Manly Dam Link Trail Upgrade King Street, Manly Vale

Traffic Safety Assessment

Ref: 128/2021
Date: November 2021
Issue: B

Figure 7 Option 1

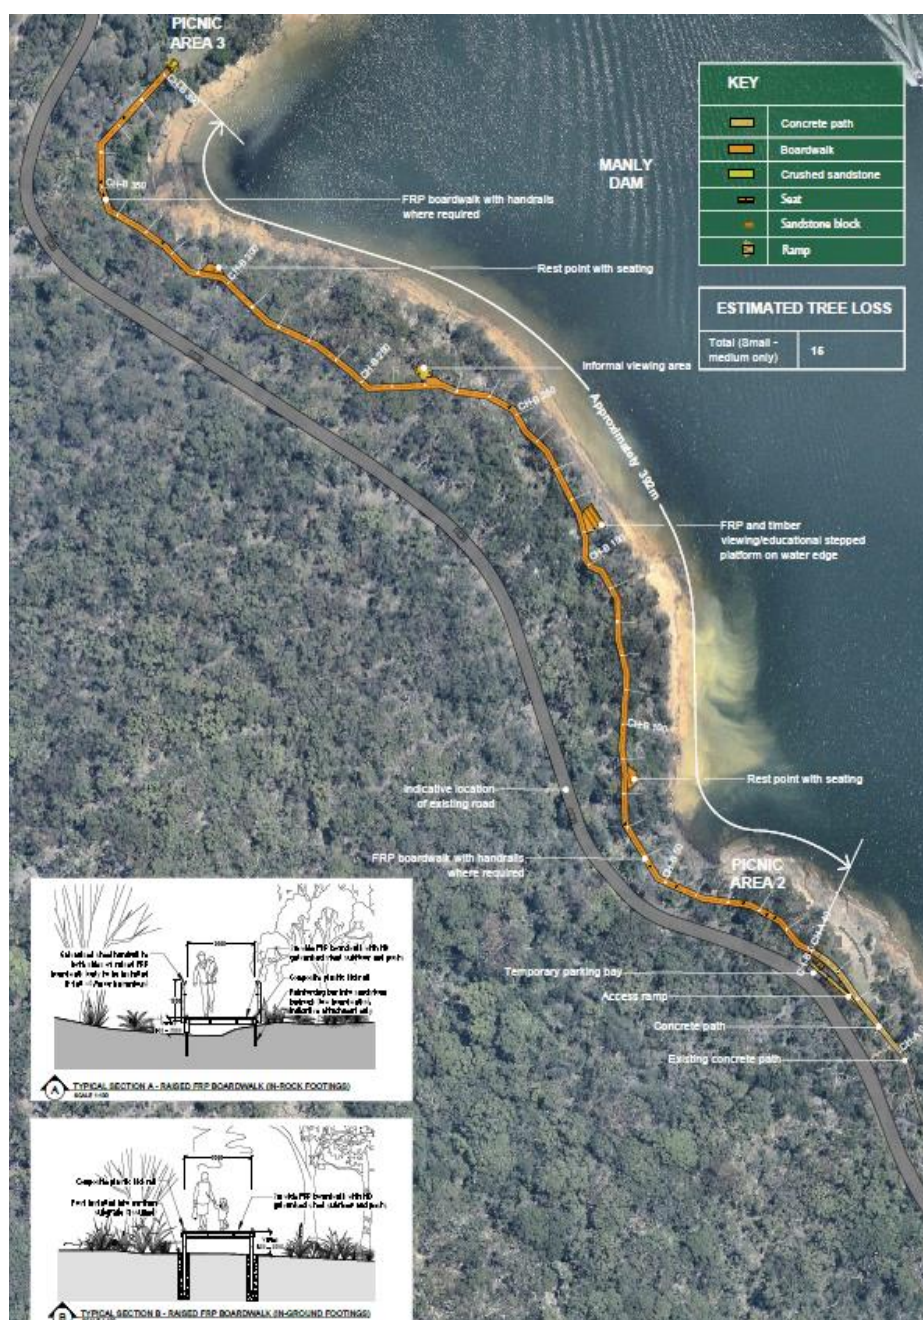
No.	Category	Description of Risk	Photo / Diagram	Likelihood	Severity	Risk Rating	Other Notes / Comments
1	Pedestrian	Specific shoes (i.e. with thin heels) might be trapped by the grates leading to foot injuries.		Improbable	Moderate	Low	
2	Pedestrian	Small items might fall into the small grate holes and result in personal property loss		Improbable	Minor	Low	
3	Pedestrian	Pedestrians might accidentally step outside the boardwalk without fence protection and result in injuries		Improbable	Moderate	Low	Recommend providing low height side barrier/protection/warning or a wider boardwalk as a buffer zone
4	Pedestrian	The paths' grades might be too steep at certain sections for wheelchair/pram access.		Highly probable	Moderate	High	DDA compliance will not be feasible with the Option 1 boardwalk design without significant cost and environmental impacts

5	Bicycle	There are cyclists (family recreational) currently identified in the study area. The cyclists' wellbeing/safety are not considered in the boardwalk option.		Highly probable	Major	High	Although it is understood that the scope of work is to improve pedestrians' walking experience, it is nonetheless desirable to provide an upgrade that complements other vulnerable user groups, particularly as there are existing risks associated with the narrow roadway (see item 6 below)
6	Vehicle	The two-lane two-way roadway is substandard, too narrow, and has limited sightlines. Vehicles often straddle in the centre of two lanes and there is very limited passing opportunity for cars, let alone for pedestrians and cyclists that were observed and recorded as regular users of the Trail.		Occasional	Major	High	Although it is understood that the scope of work is to improve pedestrians' walking experience, it is nonetheless desirable to provide an upgrade that complements other vulnerable user groups.

The assessment finds Option 1 to be highly advantageous as it removes the most vulnerable user group from the currently substandard roadway. It is acknowledged that cyclists will not be able to use the proposed boardwalk. While it is desirable for the boardwalk to also accommodate cyclists, it is recognised that there are geometrical constraints that will preclude this provision. Instead, Council may consider a partial upgrade of the existing roadway to provide a safer cycling environment (this is not a scope of this assessment).

Figure 8 Option 2

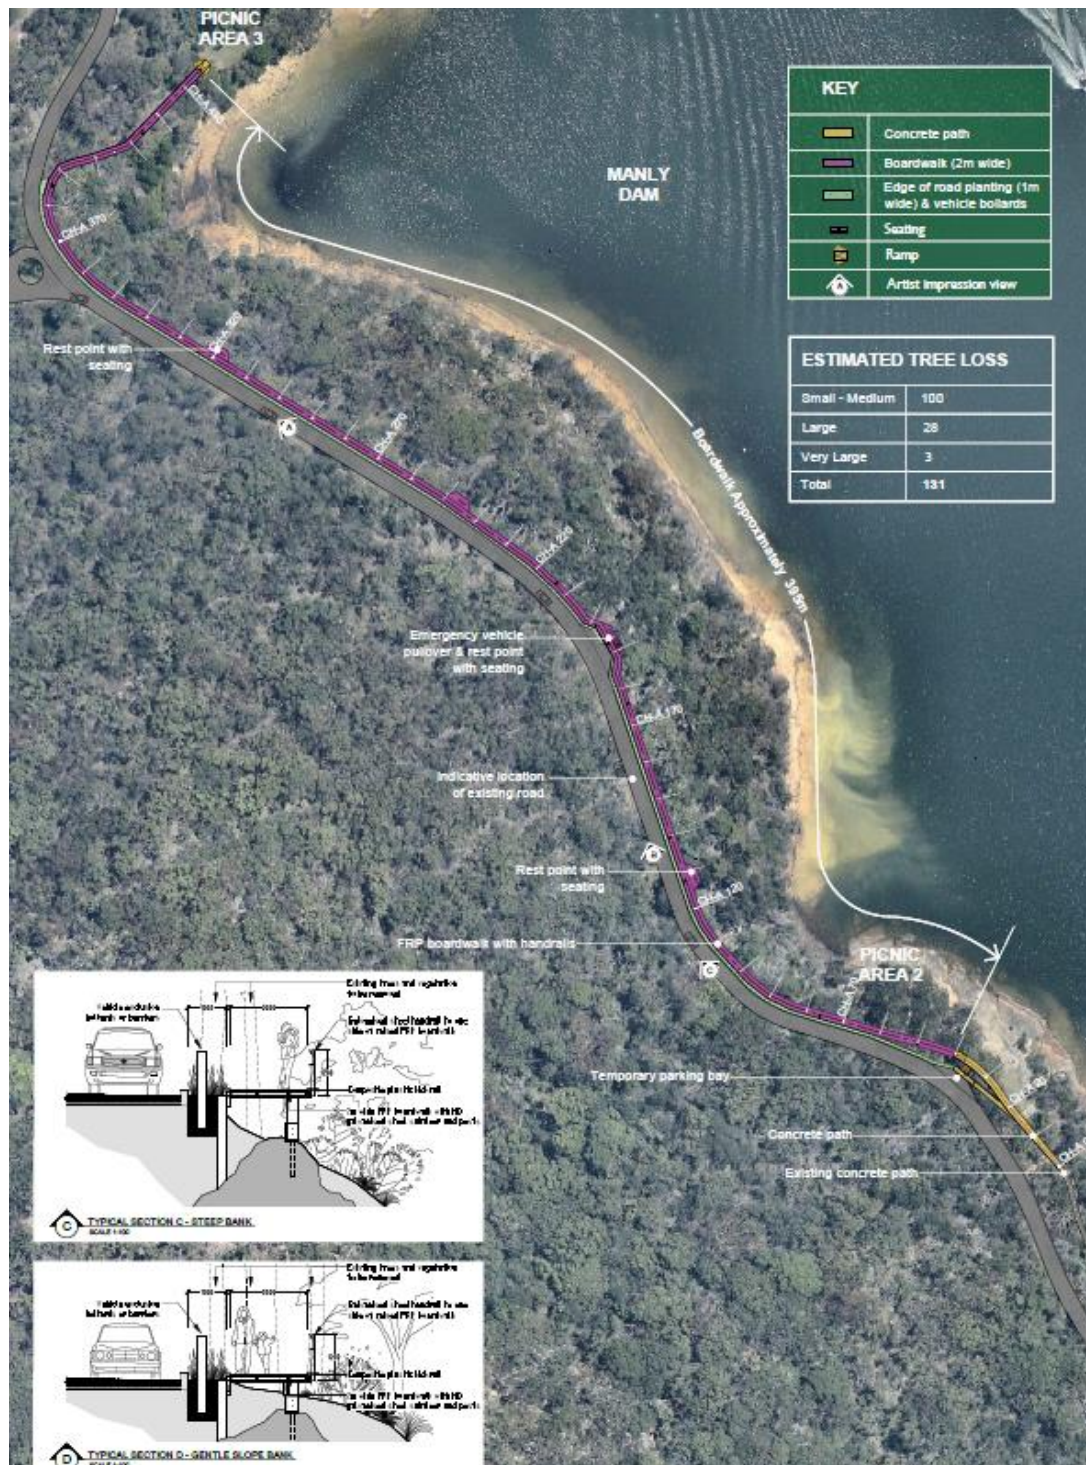
No.	Category	Description of Risk	Photo / Diagram	Likelihood	Severity	Risk Rating	Other Notes / Comments
1	Pedestrian	Specific shoes (i.e. with thin heels) might be trapped by the grates and leading to foot injuries.		Improbable	Moderate	Low	
2	Pedestrian	Small items might fall into the small grate holes and result in personal property loss		Improbable	Minor	Low	
3	Pedestrian	Due to the steep gradients of the existing roadway. The path, which will follow the roadway's terrain, could be too steep and unsuitable for wheelchair/pram access at certain sections.		Highly probable	Moderate	High	It may not be possible to achieve a DDA compliant side path due to the existing roadway slopes. It is recommended to investigate alternative alignment at steep road sections.
4	Pedestrian / Vehicle	The barrier specification is not identified in the design plan. If bollards are used, there is a risk of errant vehicles crashing over and run over pedestrians on the side path.		Occasional	Major	High	Recommend using Austroads/TfNSW compliant energy absorbing structures/bollards/barriers and ensure adequate crash buffer area provided between the roadway and side path is compliant with the relevant design criteria (product-dependent).

5	Bicycle	There are cyclists (family recreational) currently identified in the study area. The cyclists' wellbeing/safety are not considered in the boardwalk option.		Highly probable	Major	High	Although it is understood that the scope of work is to improve pedestrians' walking experience, it is nonetheless desirable to provide an upgrade that complements other vulnerable user groups, particularly as there are existing risks associated with the narrow roadway (see item 6 below)
6	Vehicle	The two-lane two-way roadway is substandard, too narrow, and has limited sightlines. Vehicles often straddle in the centre of two lanes and there is very limited passing opportunity for cars, let alone for pedestrians and cyclists that were observed and recorded as regular users of the Trail.	 	Occasional	Major	High	Although it is understood that the scope of work is to improve pedestrians' walking experience, it is nonetheless desirable to provide an upgrade that complements other vulnerable user groups.

Option 2 presents as a less desirable outcome for pedestrians when compared to Option 1. This is largely due to the footpath having to follow the roadway's alignment and terrain. As such, it will 'inherit' the already substandard sightlines and grades. As the Trail is frequently used by wheel-chair dependent user-groups, they will not be able to negotiate these grades easily, thus rendering the proposed option inadequate.

Because the footpath and an additional safety barrier will abut the roadway, the carriageway will need to be widened further to provide additional safety buffer zone (barrier-dependent) that is essential for pedestrian safety as well as for vehicle passage. The envisaged civil works will be quite significant and will be potentially cost-prohibitive in comparison to Option 1.

Furthermore, because of the required road widening, Option 2 (in its current form) will also necessitate the removal of 131 established trees along the Trail. Any further widening (as identified above) will potentially result in more tree loss.
